Edenfield Community Neighbourhood Forum

H66 Land West of Market Street, Edenfield

Masterplan / Design Code (Version V17 - Randall Thorp - September 2023)

Representations

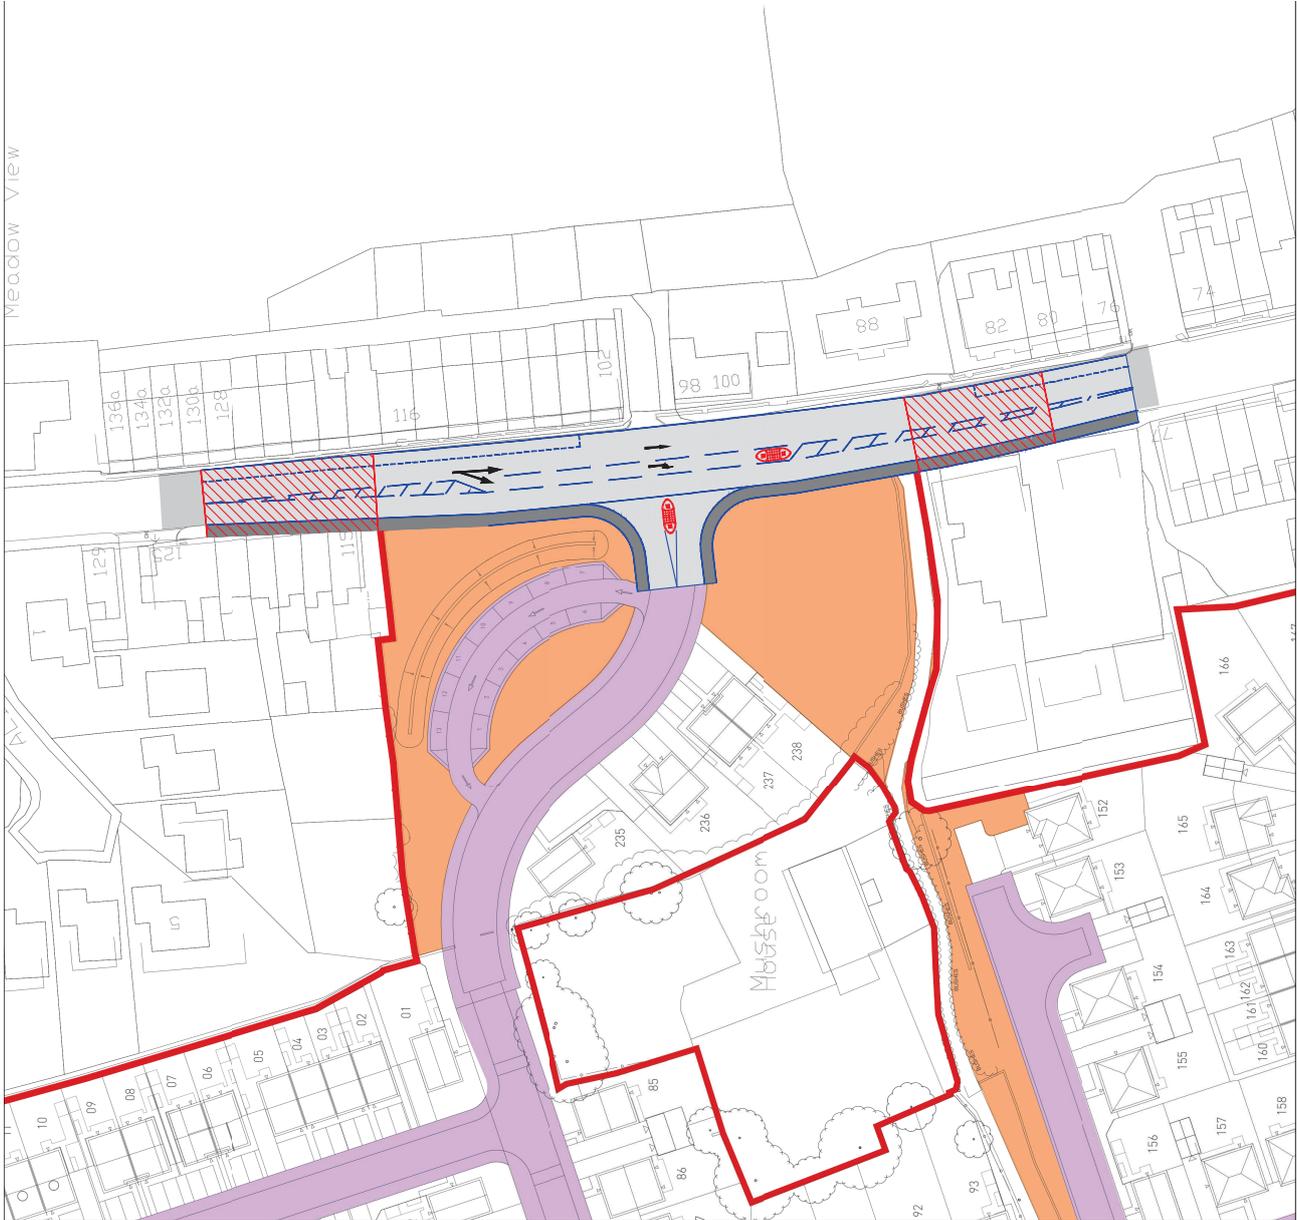
The site access is proposed onto Market Street, a highly trafficked, heavily parked upon, Designated Diversion Route for National Highways (when the A56 shuts), informal diversion route for modern sat navs when the A56 is experiencing slow traffic and key route for the many agricultural and large vehicles in the area. Market Street is also a bus route, gritter route, refuse collection route and key route for cyclists that is used by both commuters and for recreational purposes (being a hub for mountain biking in the area and also the location of the Drop Off Café a destination specifically promoted as cycle friendly).

A site access from a heavily trafficked road into a development of such a large scale should be constructed to meet the very best design practice. If Rossendale Borough Council/Lancashire County Council don't ensure that this is the case, they are putting the lives of residents, vulnerable road users (cyclists) and pedestrians including the PS children (accessing the school just 250m from the site access), at serious risk/danger of fatalities. In particular it has been suggested the following should occur:-

- Due to the number of houses on the site and the number of vehicle trips per day generated the site access must have an absolute minimum of a 35m ghost island.
